Modulars at Lightridge and Potomac Falls High Schools

IFB #24-535

Addendum #2

October 29, 2024

DOOR FRAME TYPE

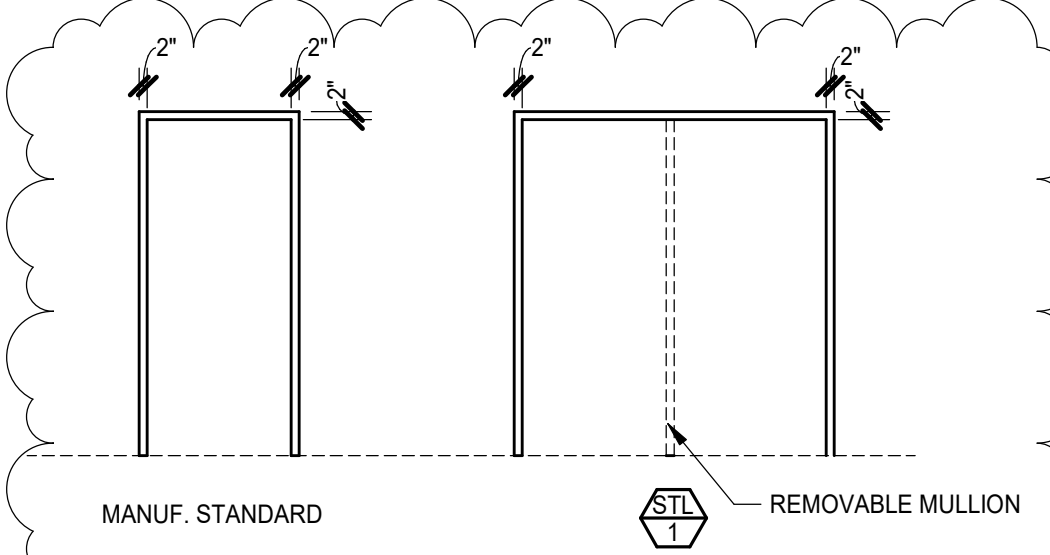
- 1.3 A2.1 Revise: Door Frame Type to show frame for exterior doors in addition to the interior door frame already shown on sheet. Refer to revisions on drawing.
- 1.4 A2.1 Add: Glazing Type to Door schedule for Exterior Doors.

1 MODULAR FLOOR PLAN
A1.1 | A2.1
1/8" = 1'-0"

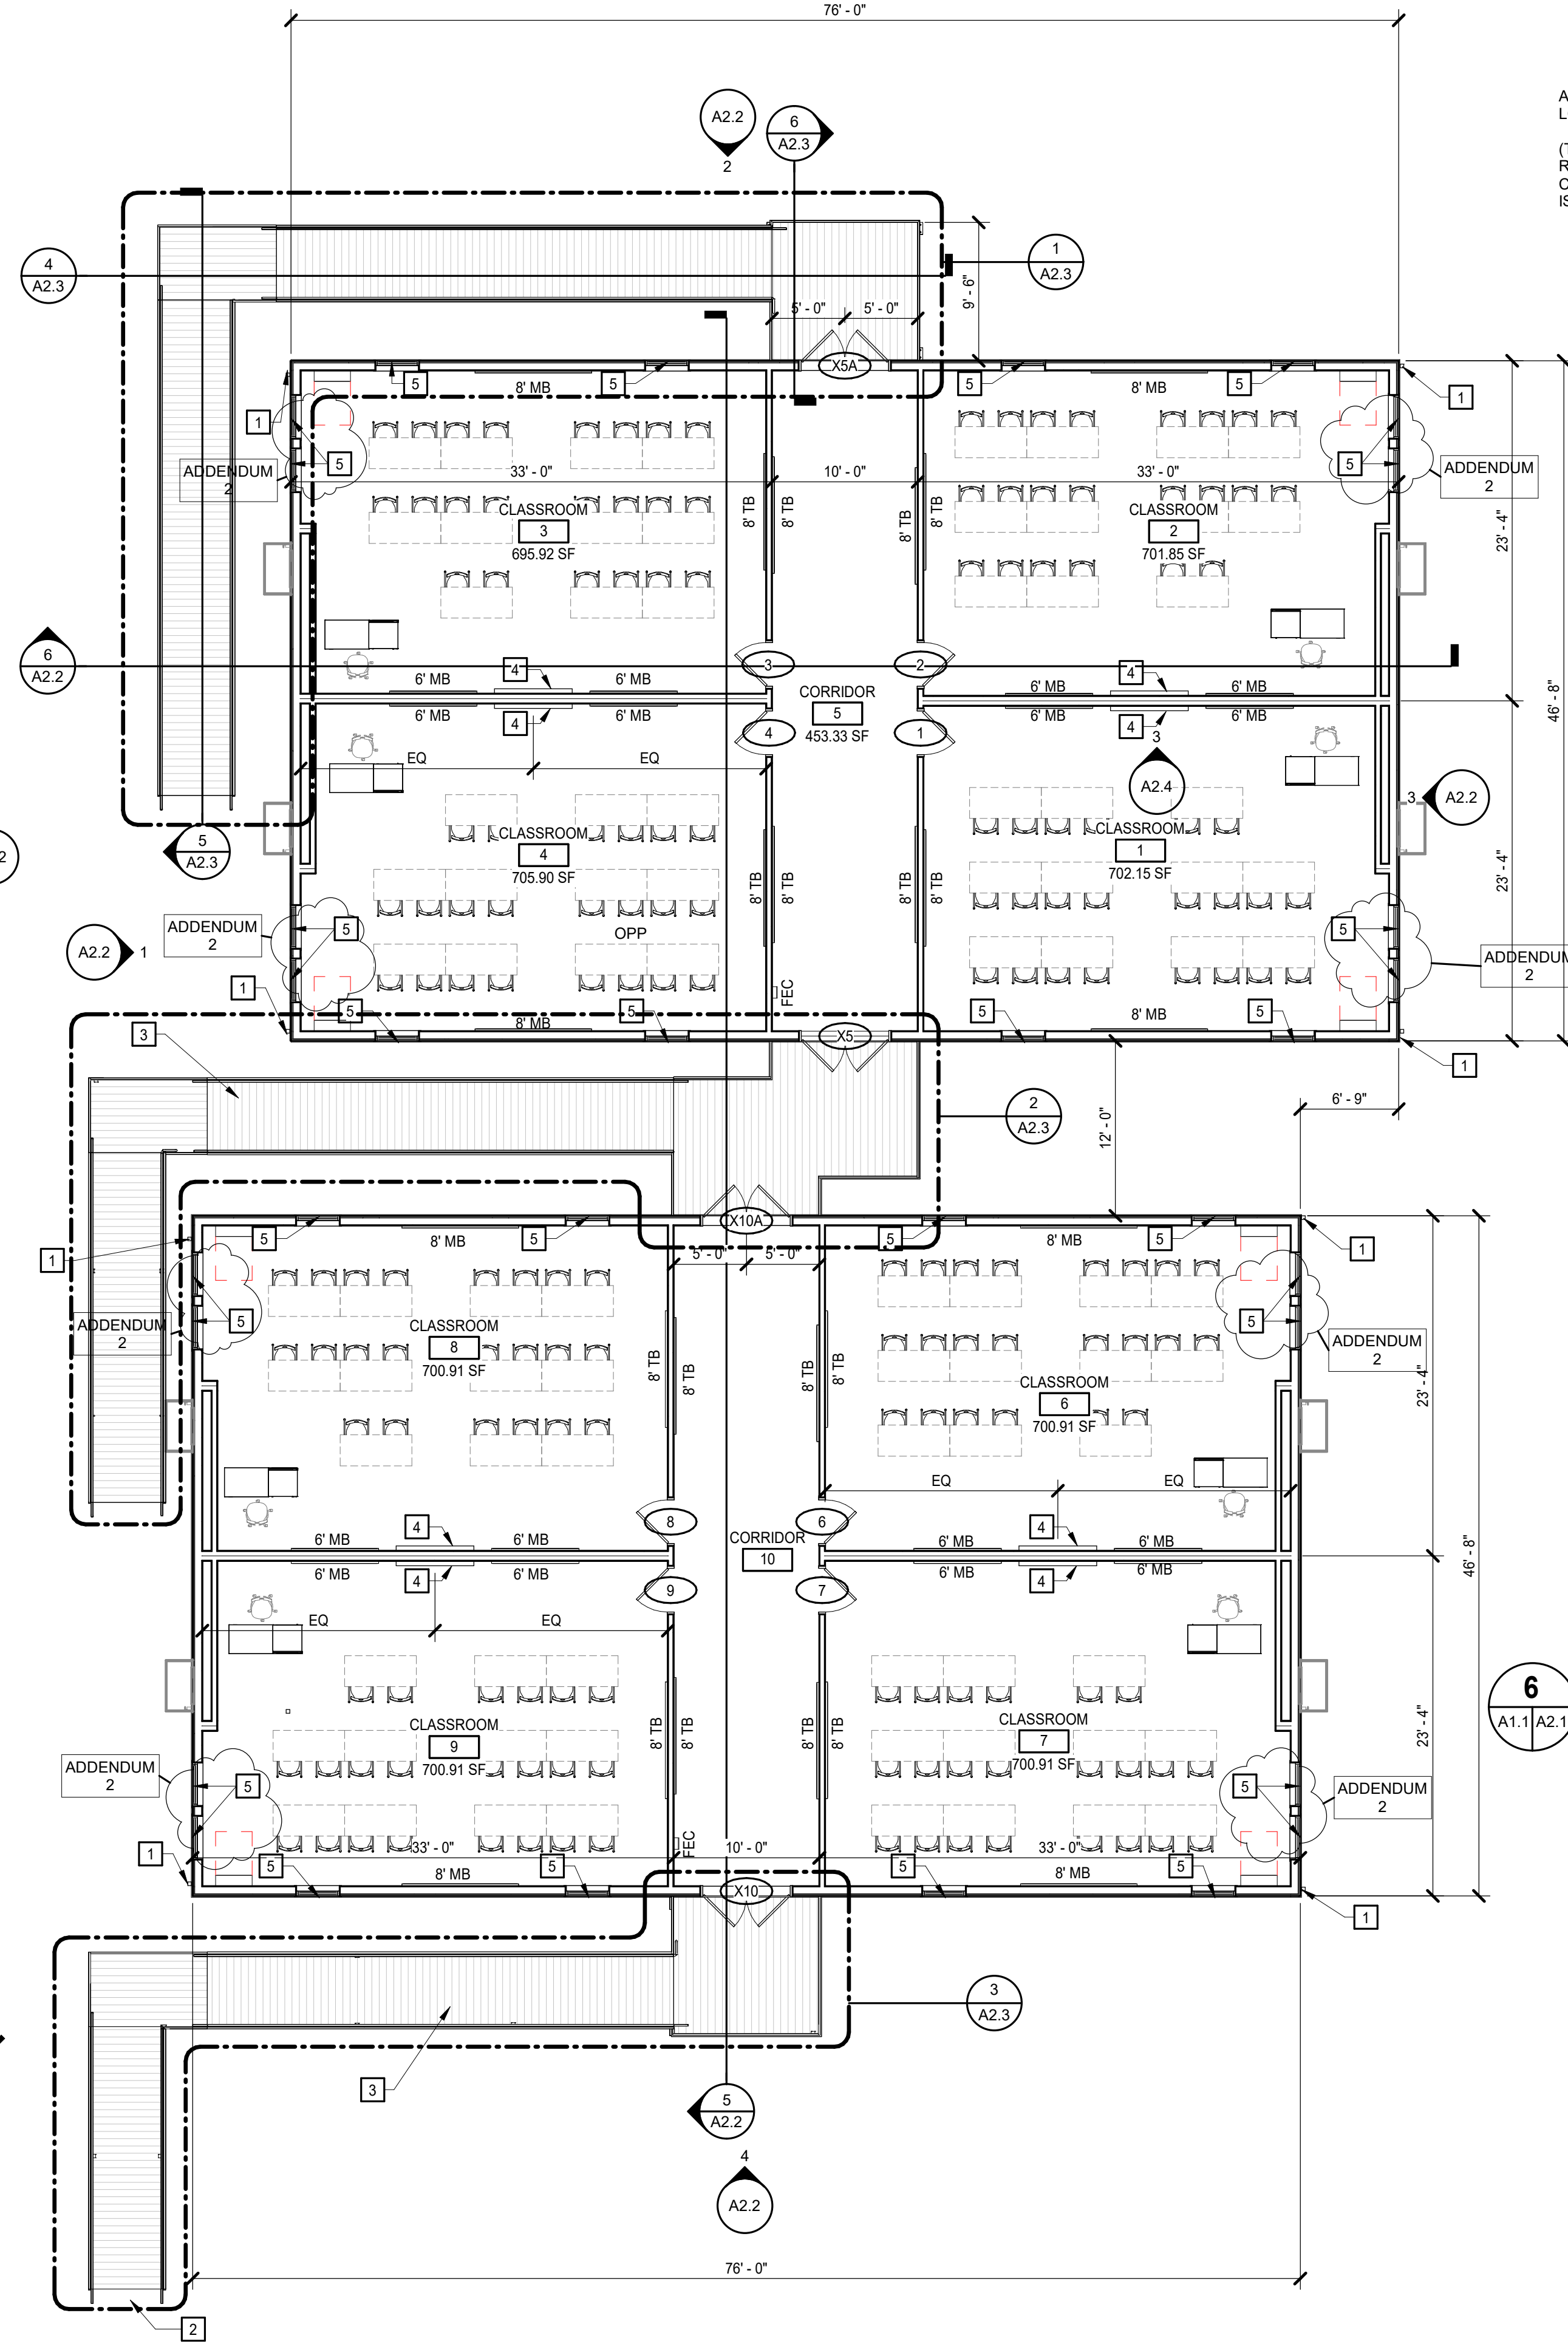
- 1.1 A2.1 Revise: Door Frame Type to show frame for exterior doors in addition to the interior door frame already shown on sheet. Refer to revisions on drawing.
- 1.2 A2.1 Add: Keynote #5 for "SURFACE MOUNTED VINYL 1" MINI SLAT TYPE V-BLIND, WHITE. COORDINATE WITH WINDOW..." Refer to revisions on drawing.
